Plas Power Solar and Energy Storage Project

3.0.4 Outline Construction Traffic Management Plan

Stage 1 Road Safety Audit Response

- 1.1.1 This Stage 1 Road Safety Audit Response Report has been prepared in response to a Stage 1 Road Safety Audit (RSA) carried out by TMS Consultancy, dated 1st December 2023. The RSA was undertaken for the proposed access arrangements for the Plas Power Solar and Battery Project.

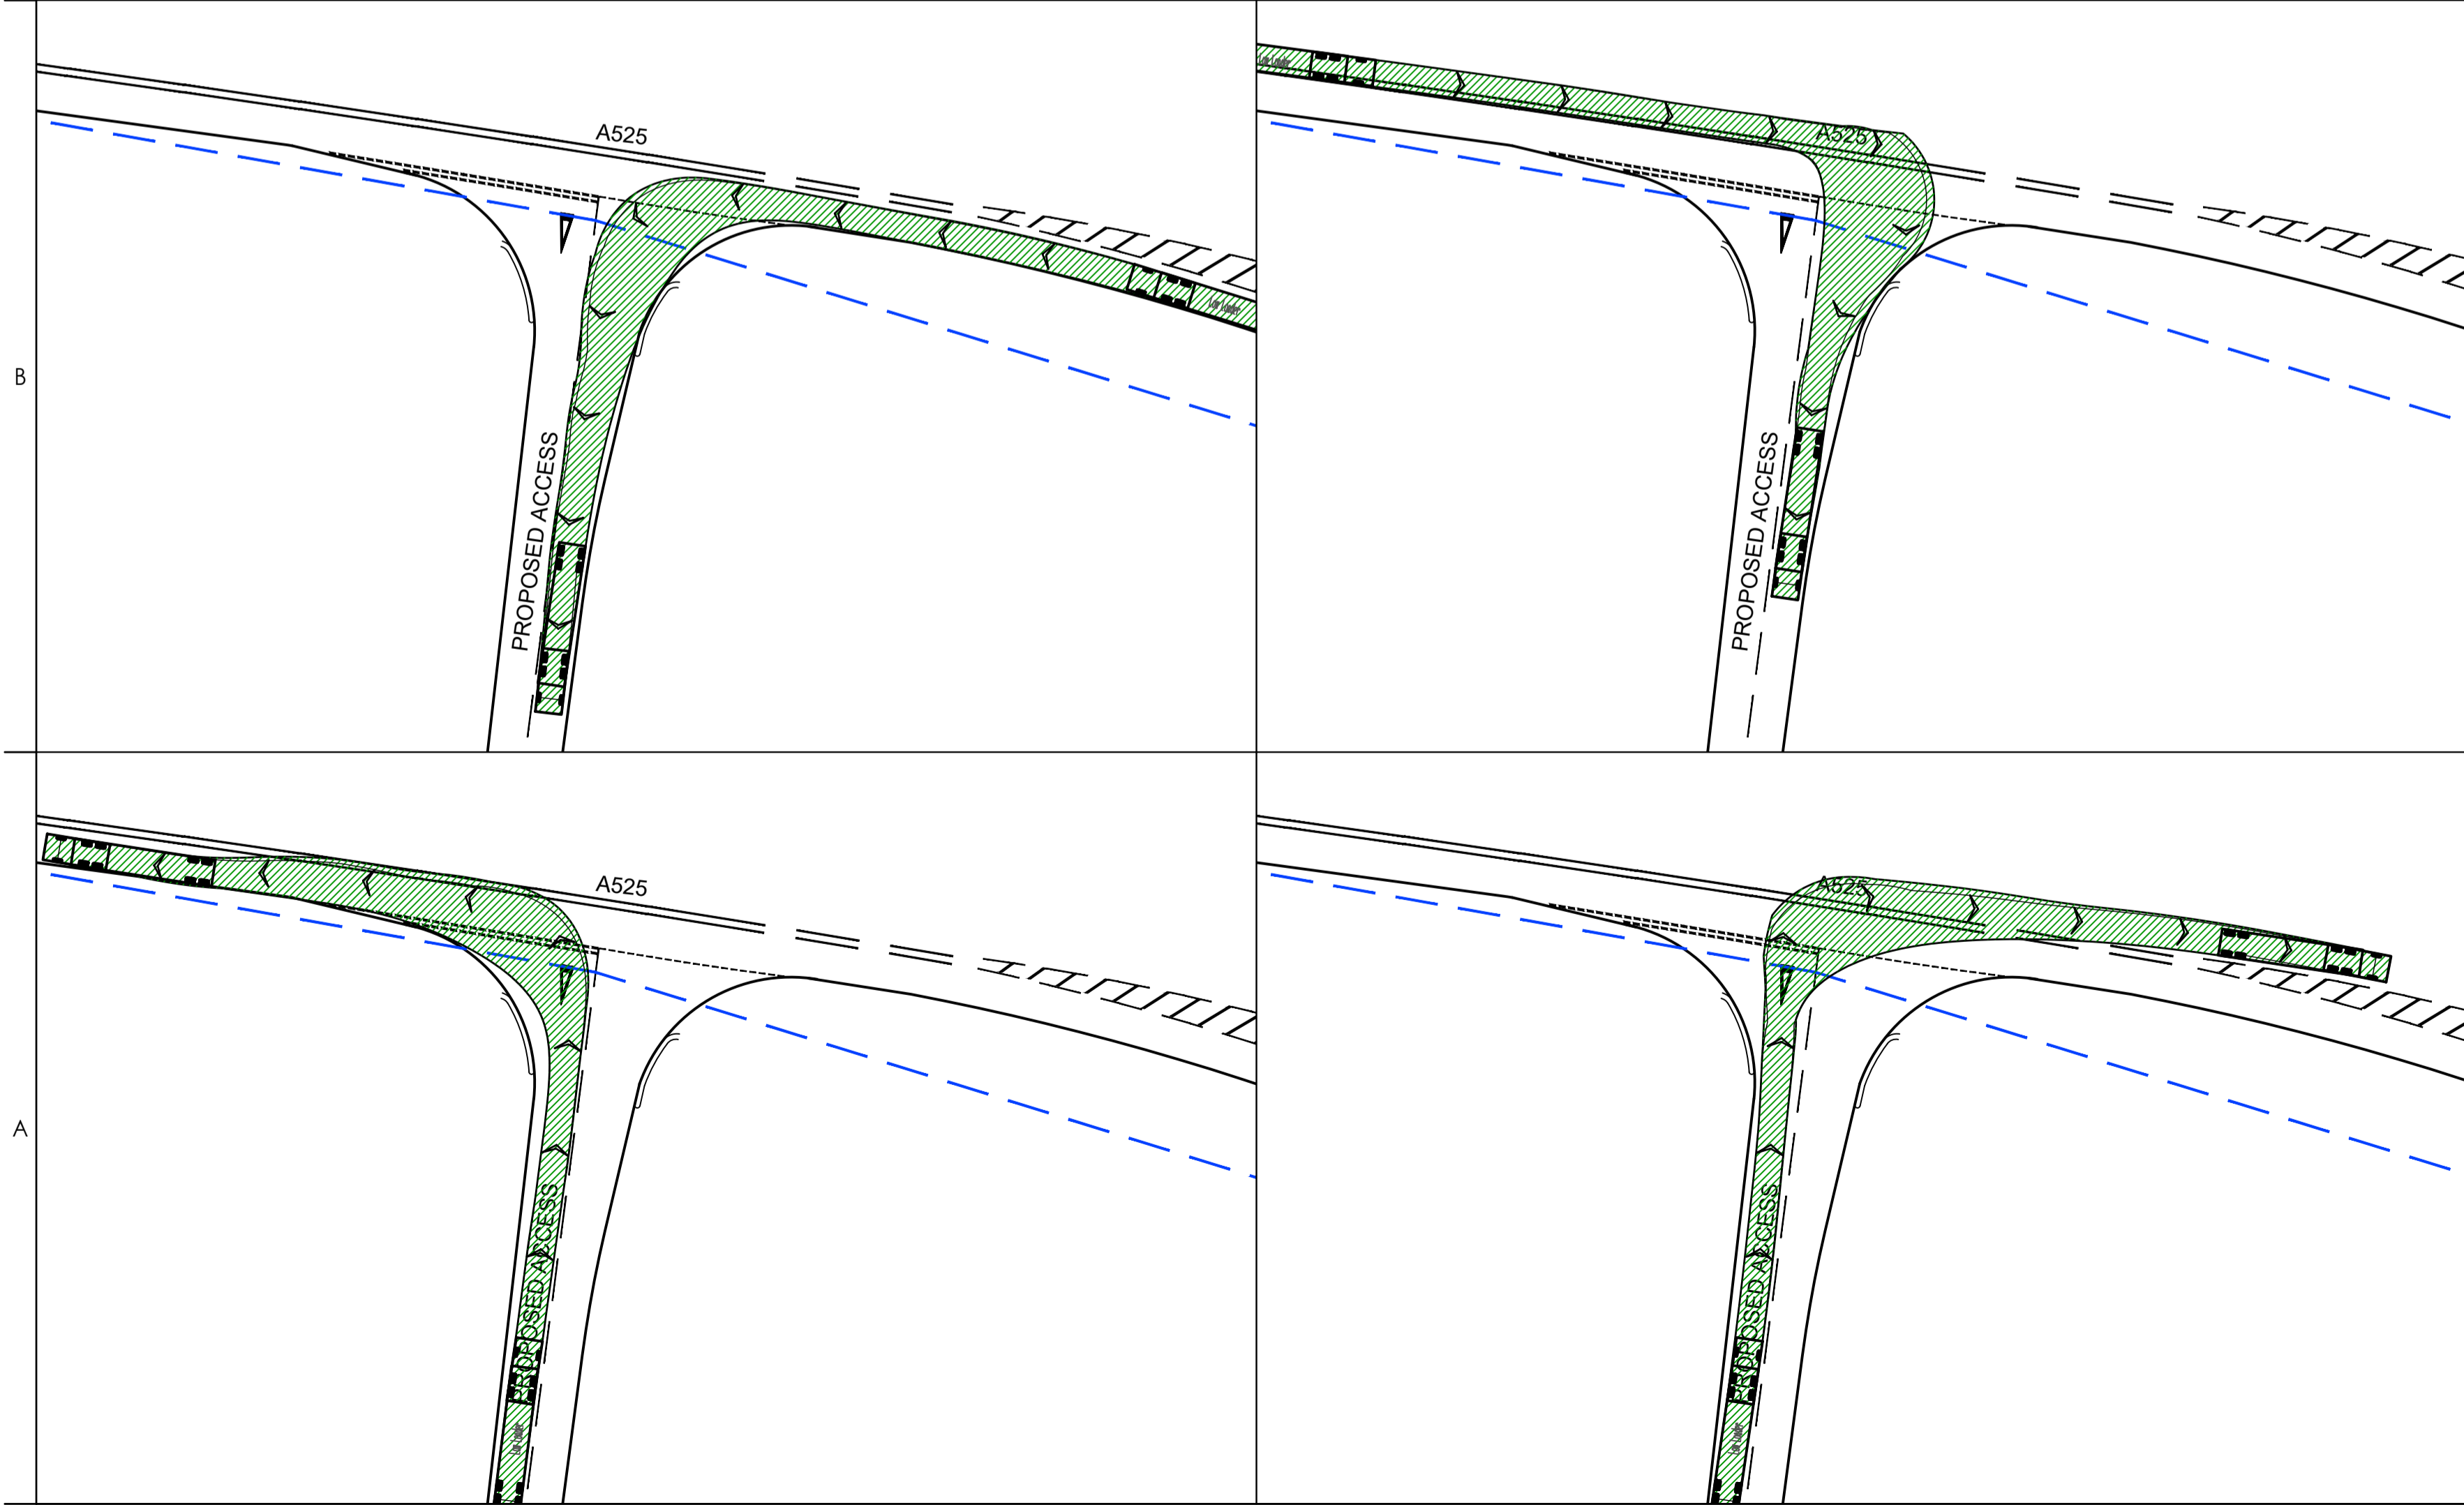
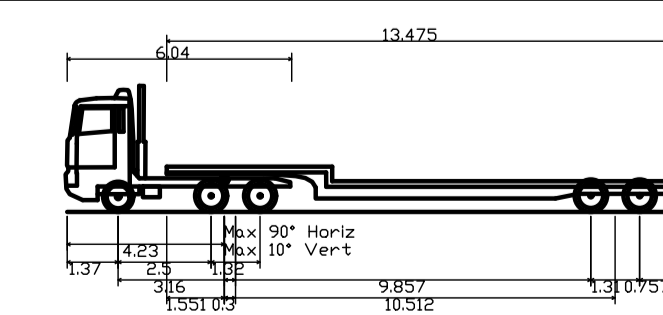
Approximately 25m of stone wall will be relocated along the proposed access road radii.

85th percentile eastbound speed = 45.52mph. This equates to 97m minimum SSD. 131m is achievable.
